EXPERT WITNESS STATEMENT
BY
STANLEY EDWARD DENHOED, P.ENG., M.SC.

OMB CASE NO. PL071044
OMB File No. PL071047 PL107063 PL1071065

3: OPINIONS

Figure 1: Estimated Area Contributing to ESPA 19

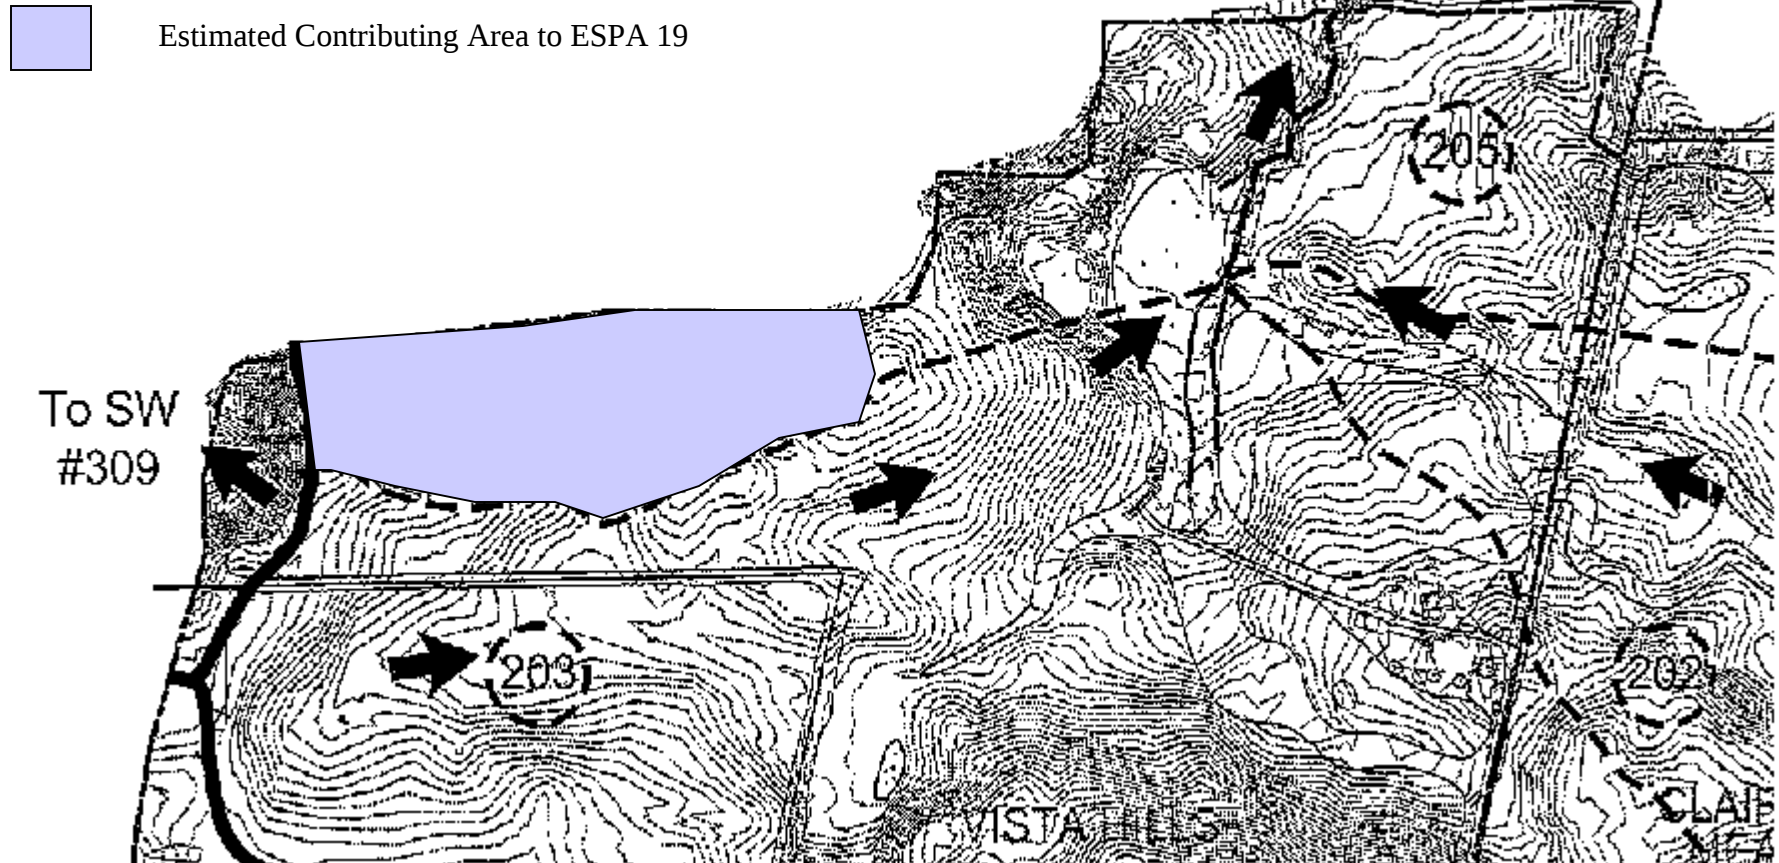
1. The development of the Waterloo West Side Development Lands will remove a significant contributing source area for an environmentally sensitive feature in the Environmentally Sensitive Protection Area 19 (ESPA 19). Specifically, the wetland area identified to me as W-12 within ESPA 19 will have the portion of its contributing source area that falls west of the ESPA 19 buffer area removed during the development of Waterloo West Side Development Lands. That is, water that is presently running off of the Waterloo West Side Development Lands and into the wetland will be diverted into a stormwater management area adjacent to Clair Creek as a result of the development. Therefore, if the lands are developed and serviced as described in the Preliminary Servicing Report (Stantec, 2005a) there will be a significant decrease in runoff presently supporting wetland W-12. The approximate location of the contributing area that will be lost is shown on Figure 1 and includes portions of the proposed development on Black Willow Street and Black Spruce Street. During a site visit of ESPA 19 on Friday, July 11th, 2008 I observed runoff from the Waterloo West Side Development Lands into ESPA 19 and this water eventually discharged into wetland W-12, shown on Figure 2. It is my opinion that the loss of this substantial portion of the contributing area of this wetland will significantly affect the water balance of this wetland. In order to preserve the hydrological balance of this wetland in ESPA 19, it will be necessary to exclude the wetland surface water catchment area from development.
